PCN – Process Change Notification

Change:	OMB.915.B06F21
Date:	2017/07/07
Author	Bonnie Chen

Model#	Part Number	Changes
915MHz 6dBi Omni Antenna, with N Type Female Connector, U-Bolt, 1095mm Length Ø70*53mm	OMB.915.B06F21	<ol style="list-style-type: none"> 1. Amend Antenna Length. 2. Amend Details of drawing.

Illustration of Change

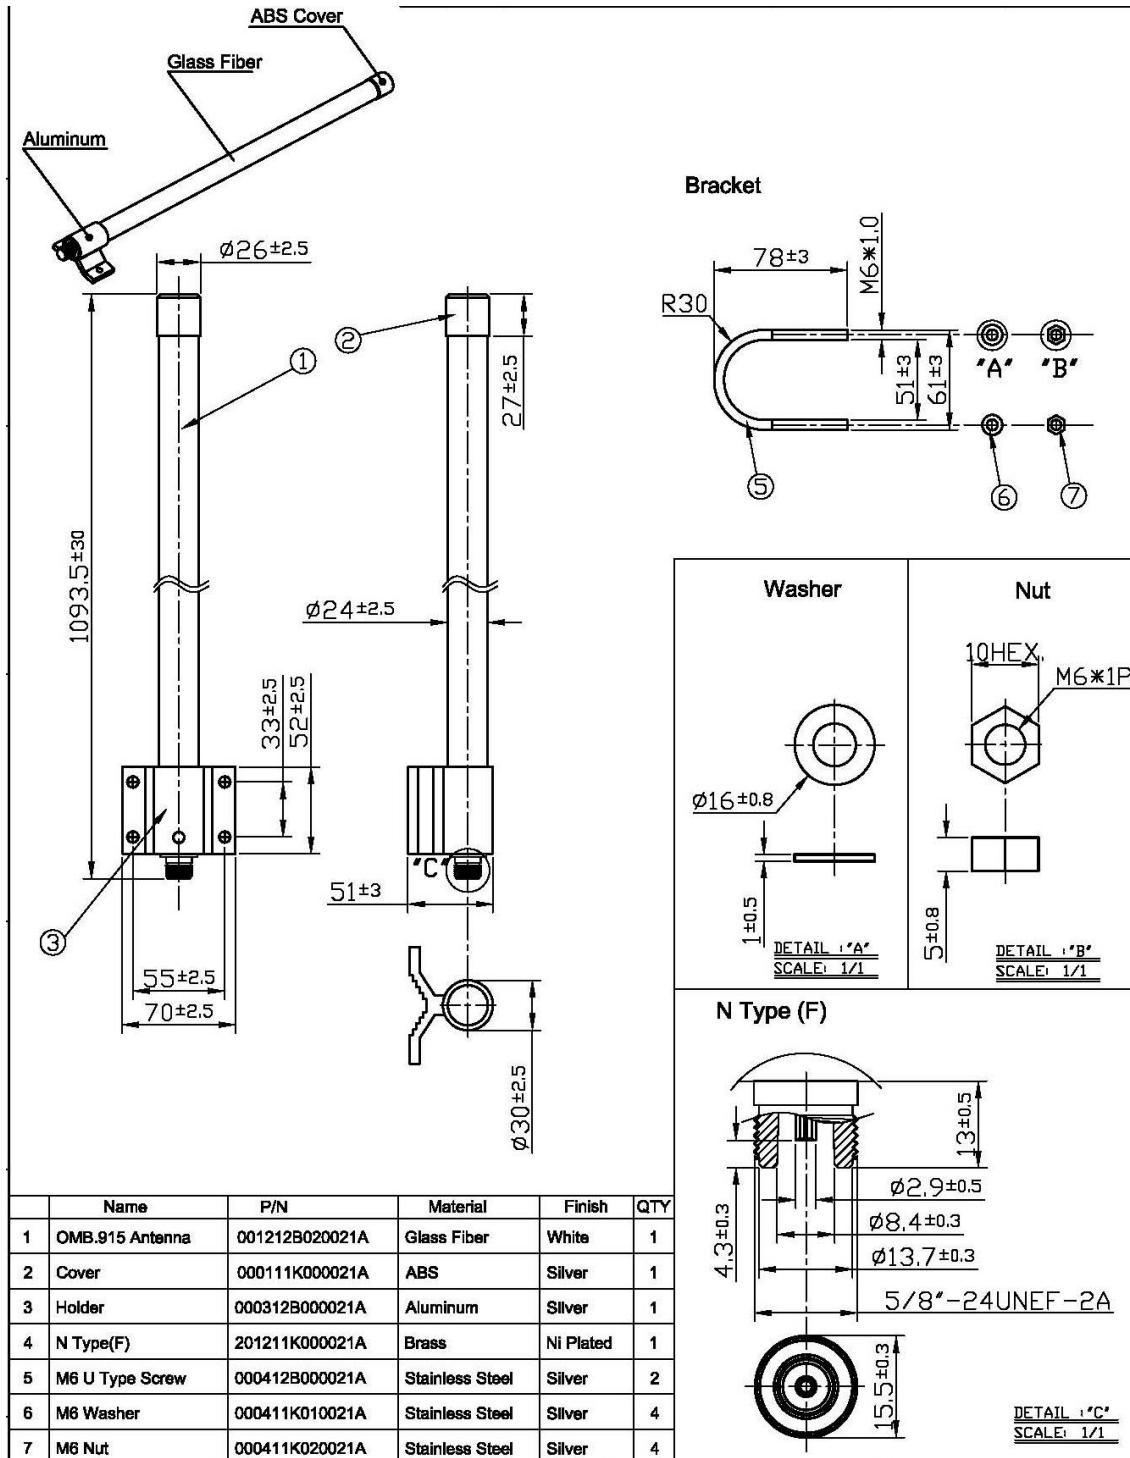
1. Amend Antenna Length from 1093.5mm to 1095mm.
2. Remove Washer and Nut dimensions.
3. Amend BOM.
4. Amend Title of drawing.
5. Add Dimensions.
